FILE No. TP/99/0733

RIGHTS OF
LIGHT,
SUNLIGHT AND
DAYLIGHT

AUBREY WALK
LONDON W8

Campden Hill Reservoir Site for St James Homes

Section showing Thorpe Lodge and the South Terrace with 25° line shown.

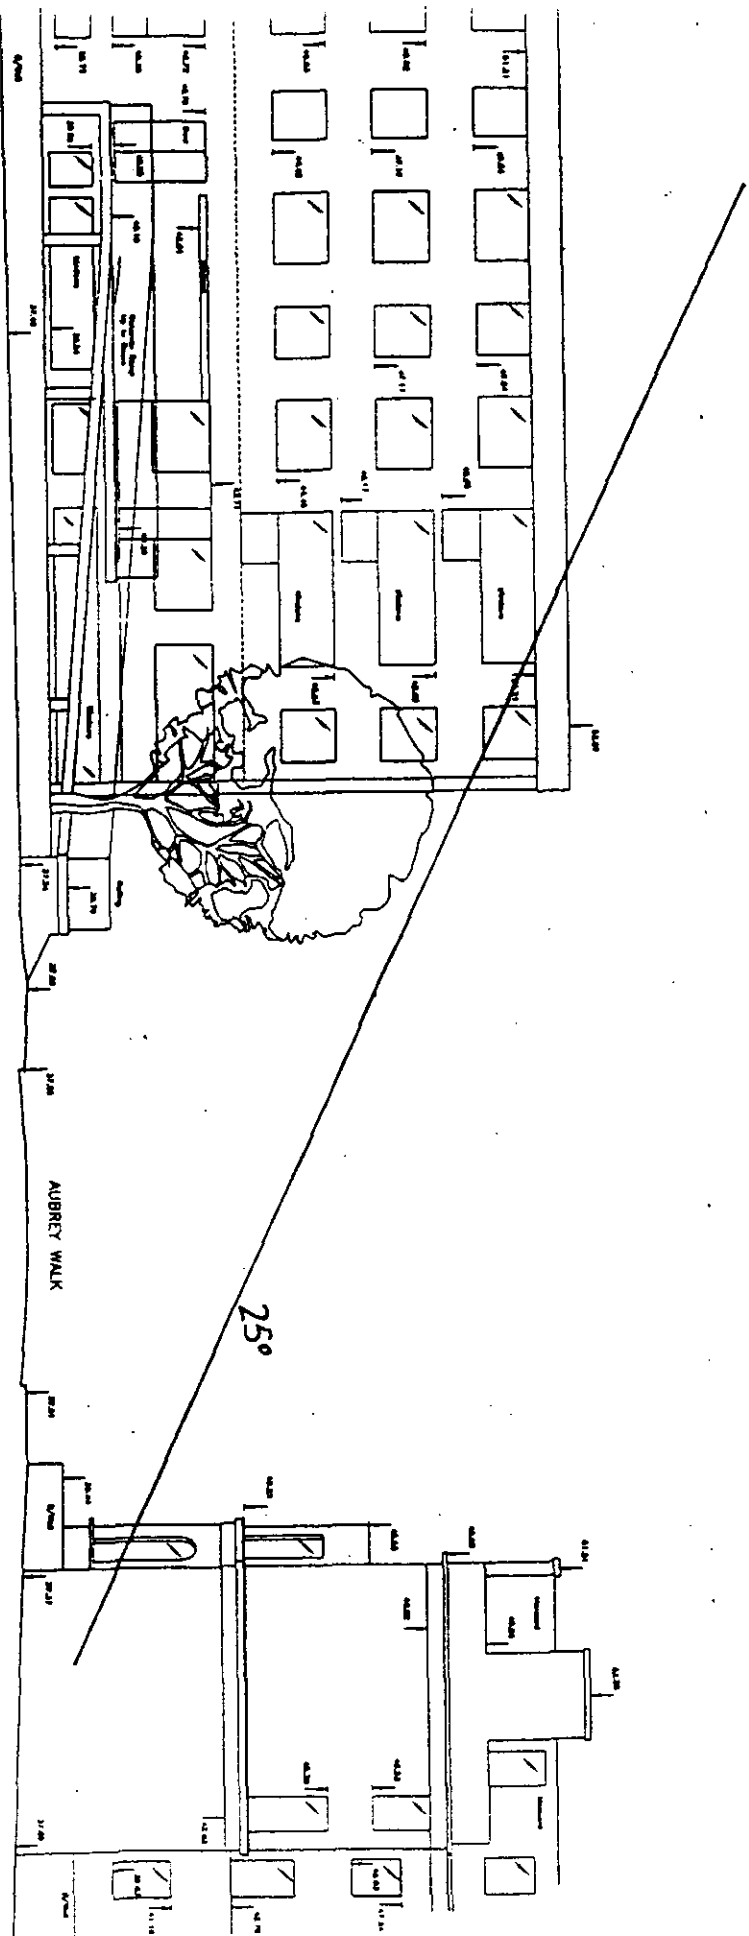
From the daylighting point of view, we have verified that the angle of obstruction formed by the new buildings at the centres of the ground floor windows will intrude above the 25° line at 27°. We have, therefore checked the sky factor along the window wall and find that it is 27.5% so that the criteria given in Section 2.2 of the Code of Practice published by the BRE is satisfied. Examination of the section drawing attached shows this situation pictorially.
